3 June 2022

218062

## **SECTION 4.55(1A) MODIFICATION APPLICATION to SSD-9374 BREWERY YARD BLOCK 4B – MODIFICATION 1**

**Figure 3** Proposed new void to the Level 1 slab

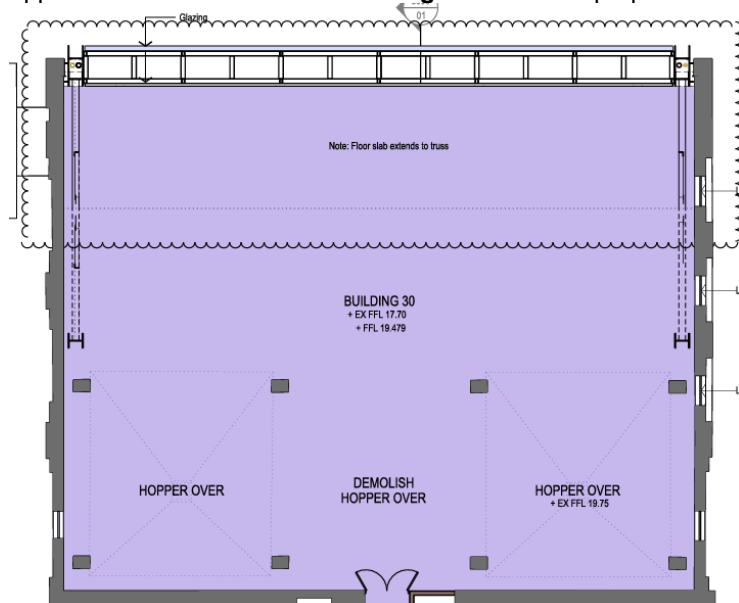
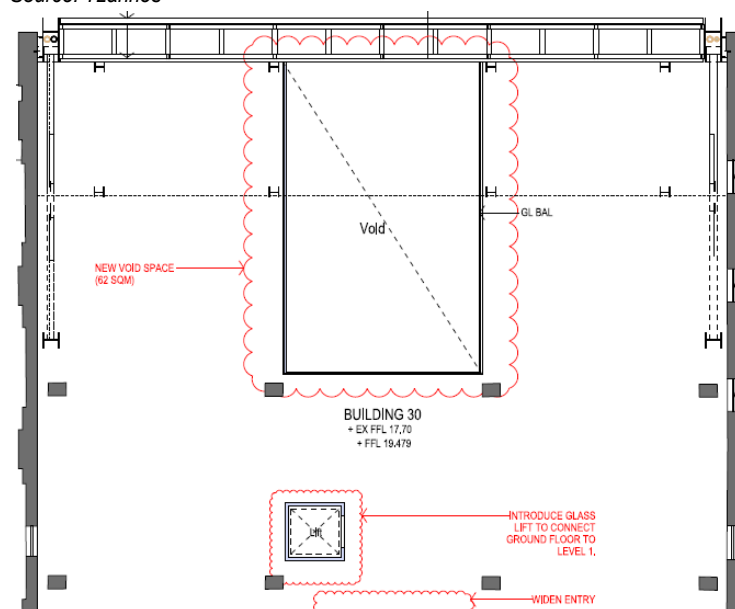
The addition of a void to the Level 1 slab in Building 30 is to provide a connection between Level 1 and the ground floor, as well as improve the views from the ground floor to the coal hoppers. The addition of a void in this location will result in an overall GFA reduction of 62m<sup>2</sup>. Furthermore, the new void along with the existing Level 2 void creates a triple height volume that is anticipated to enhance the significance and interpretation of the space. The approved Level 1 slab is shown in **Figure 2** and the proposed new void is shown in **Figure 3**.

**Figure 5** Proposed reconfiguration of Building 30 entry and modification of heritage interpretation area in Building 26

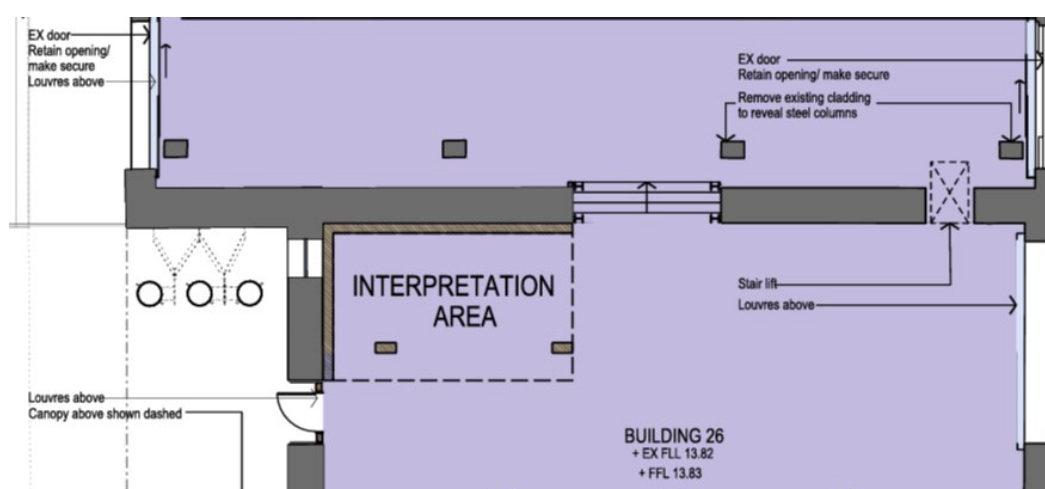
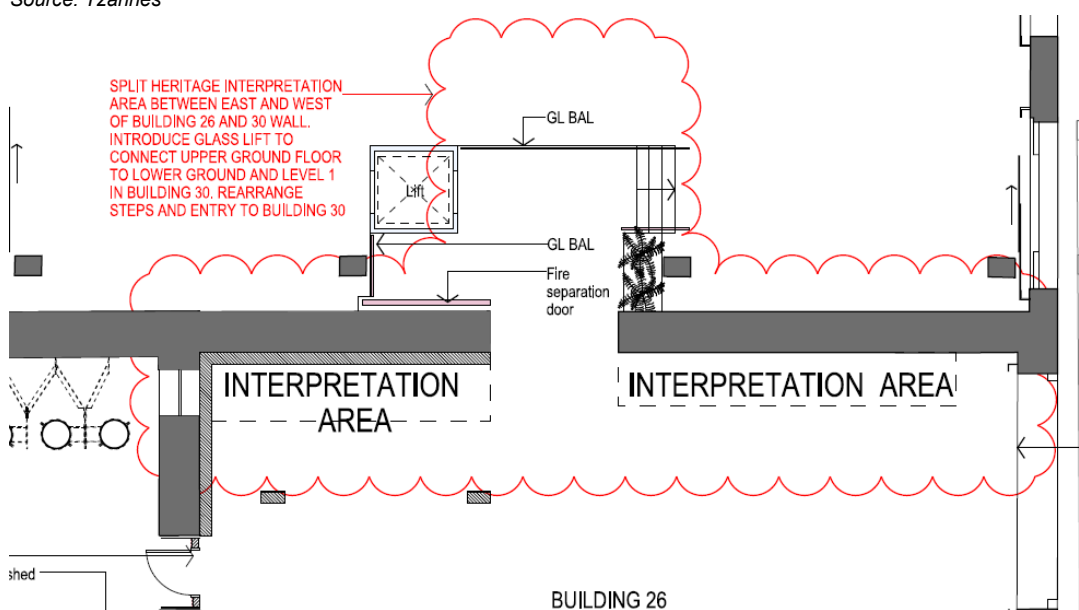
The reconfiguration of the entry and amendment to the heritage interpretation zone are proposed to better accommodate the changes above and to suit the interpretation strategy for the area. In particular, the reconfigured entry into Building 30 involves the rearrangement of the steps to accommodate the addition of the new glass lift (refer to below).

Furthermore, the amendment to the approved nominated heritage interpretation area in Building 26 involves splitting it between two locations. The nominated heritage interpretation area was originally approved to be concentrated in the north western corner of Building 26. It is proposed the approved nominated heritage interpretation area be amended by reducing the size of the north-western area and expanding the heritage interpretation area across the entire length of the northern wall of Building 26. The approved entry into Building 30 and nominated heritage interpretation area are shown in **Figure 44** and the proposed modifications are shown in **Figure 55**.

**Figure 6** Proposed new glass lift connecting Ground Floors and Level 1

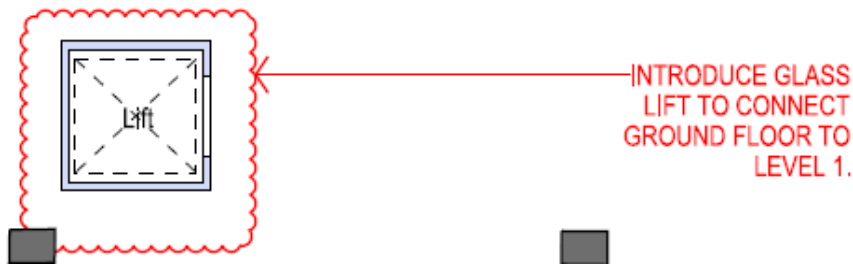
A new glass lift is proposed on the ground floor in Building 30 to connect upper and lower ground floors with Level 1 (shown in **Figure 6**). This is proposed to improve accessibility and provide equitable access between these levels. The new lift is proposed to be located close to the entrance of Building 30 but setback from the wall. Furthermore, the proposed lift is limited to ground, upper ground and Level 1 spaces only, and therefore will not impact on the hoppers which extend only midway between levels 2 and 3.

**Figure 8** Proposed extension of Level 3 Mezzanine floor area viewed from Level 4

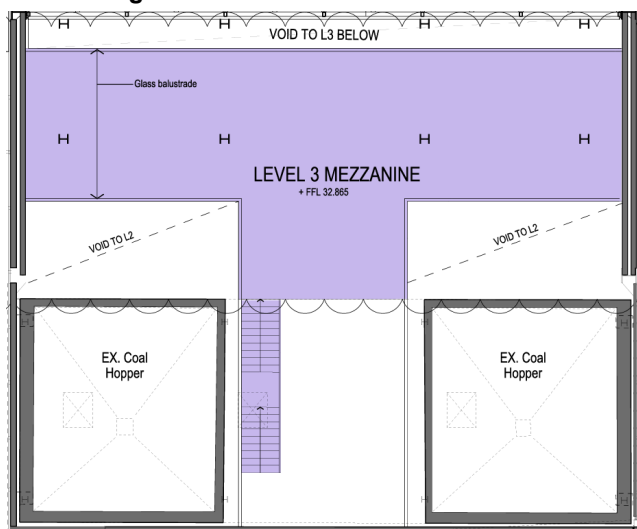
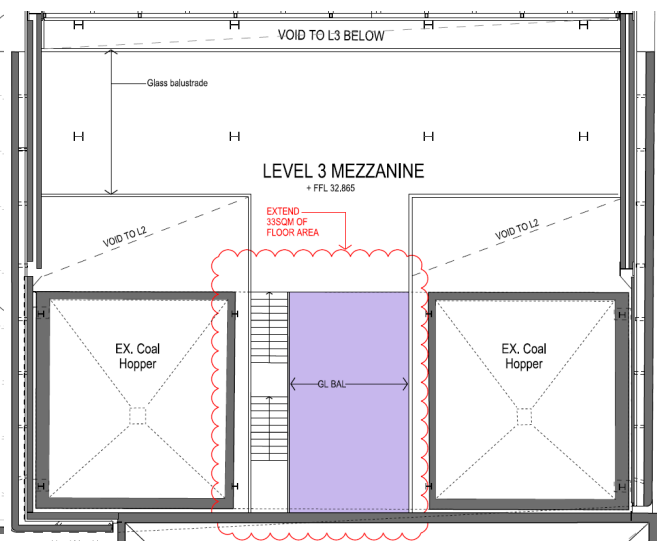
The modification seeks to increase the GFA of the Level 3 mezzanine by approximately 33m<sup>2</sup>. The increase in GFA is offset by the reduction of GFA of the Level 1 slab, and is a result of infilling an approved void between the hoppers on the Level 3 mezzanine. The proposed new mezzanine floor is setback from the hoppers, incorporating a glass balustrade and will not physically impact on the structures.

It is to be noted this modification does not involve changes to the approved voids on the northern side. Filling the approved void between the hoppers will improve views and appreciation of the heritage significant coal hoppers. This is due to the previously approved mezzanine design only enabling close up views of the hoppers from the northern side. The new mezzanine floor will increase the accessibility and interaction with the hoppers at this level as it allows for movement between the two remaining hoppers. Overall, the proposed extension increases the floor space in this location, however with the removal of the floor space on Level 1, there is overall decrease of GFA by 29m<sup>2</sup> within Building 30. The approved Level 3 mezzanine is shown in **Figure 7** and the proposed extension is shown in **Figure 8**.

**Figure 10** Location of proposed new sliding door entry into Building 23 from Brewery Yard Forecourt (left) and on the northern elevation of Building 23 (right)

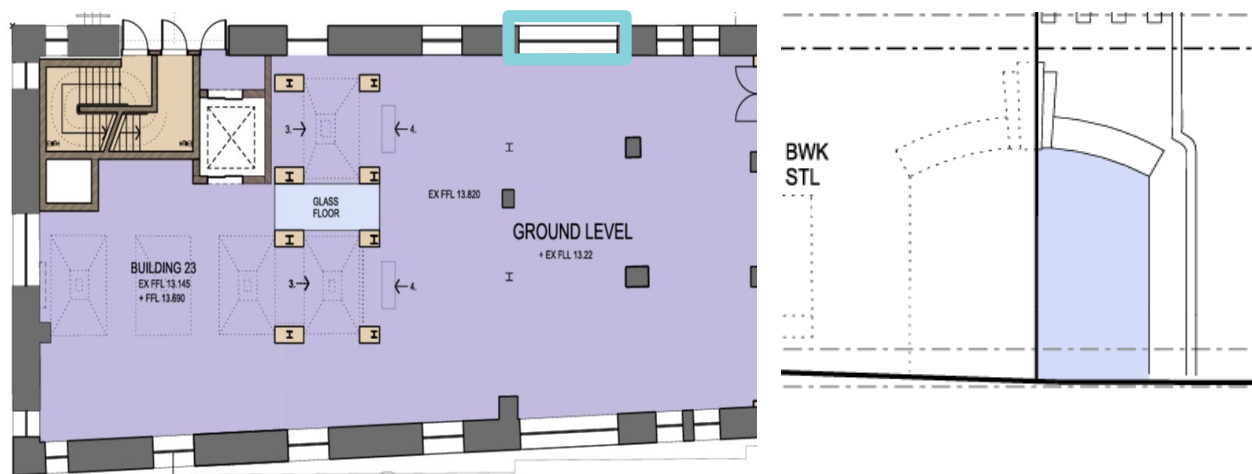
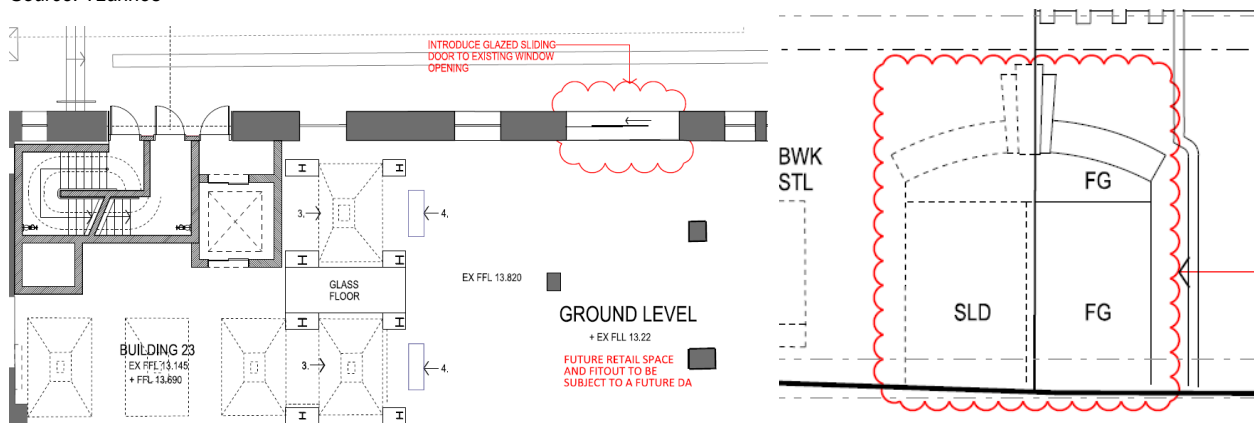
This modification is proposed to accommodate an additional entry from the external forecourt in Building 23 ground floor (refer to **Figure 10**). It is proposed to change an approved fixed window on the ground floor of the northern façade of Building 23 (refer to Figure 9) to a sliding glass door and entrance.

**Figure 12** Proposed Deletion of Level 2 Mezzanine in Building 22

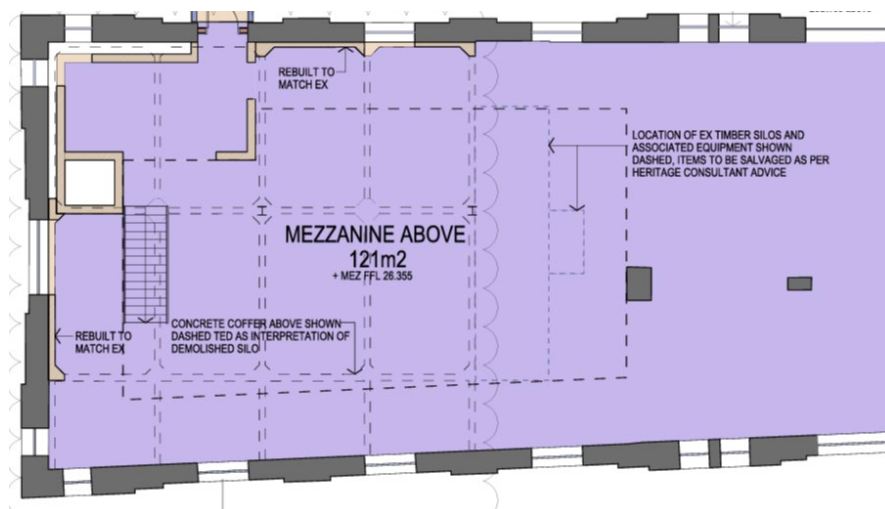
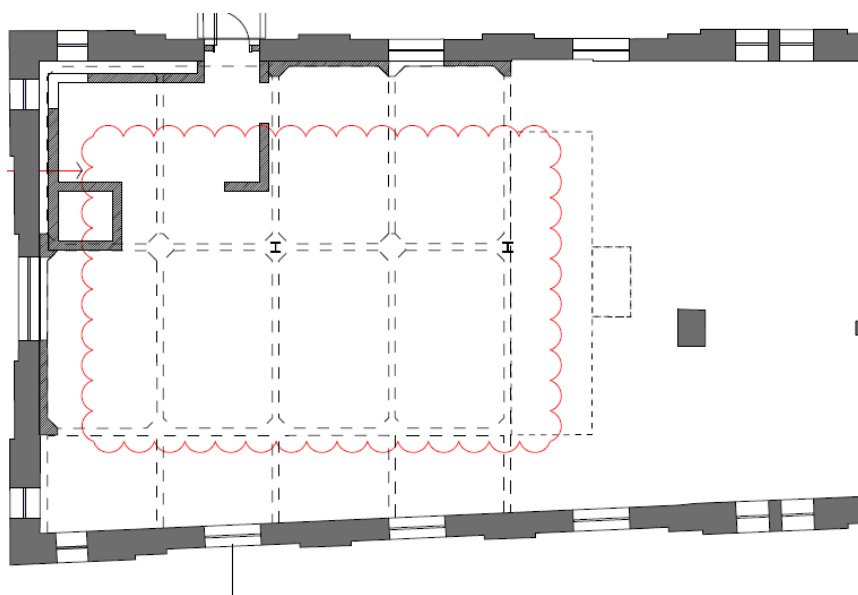
This modification relates to the deletion of the Level 2 mezzanine, resulting from ongoing design development to improve circulation space and efficiencies in pedestrian logistics to better suit a future commercial space fit out. The proposed removal of the Level 2 mezzanine will retain the spatial character of this part of Building 22 and provide additional interpretative viewing capacity of the remnant industrial heritage items in this location. The approved Level 2 mezzanine is shown in **Figure 11** and the proposed deletion is shown in **Figure 12**.

**Figure 14** Proposed widening of Level 1 opening between Building 26 and Building 30

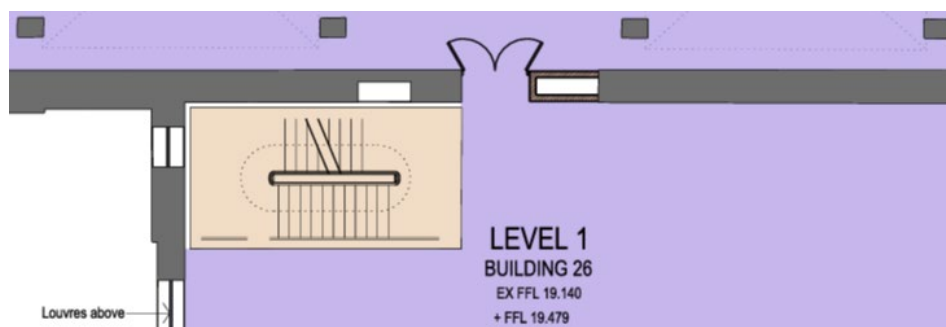
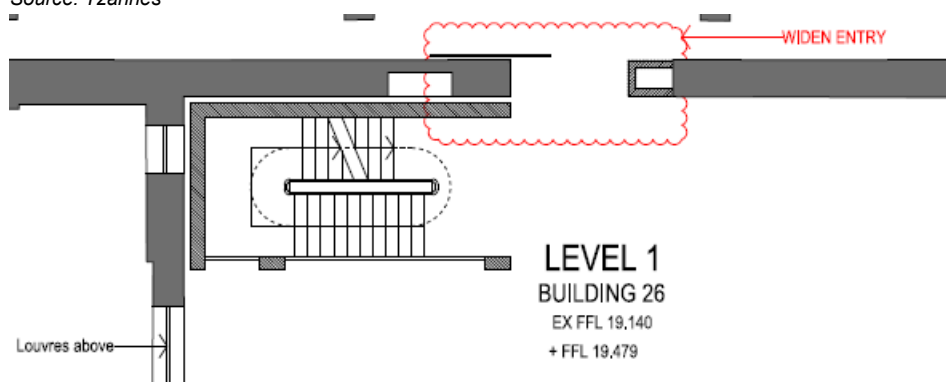
This modification is proposed due to a tenant request to improve the flow between Building 26 and Building 30. The proposed widening will have a positive outcome in both architectural and heritage terms, as the larger opening will facilitate improved views to the underside of the coal hoppers from Building 26 into Building 30. The approved opening between the two buildings is shown in **Figure 13** and the proposed widening is shown in **Figure 14**.
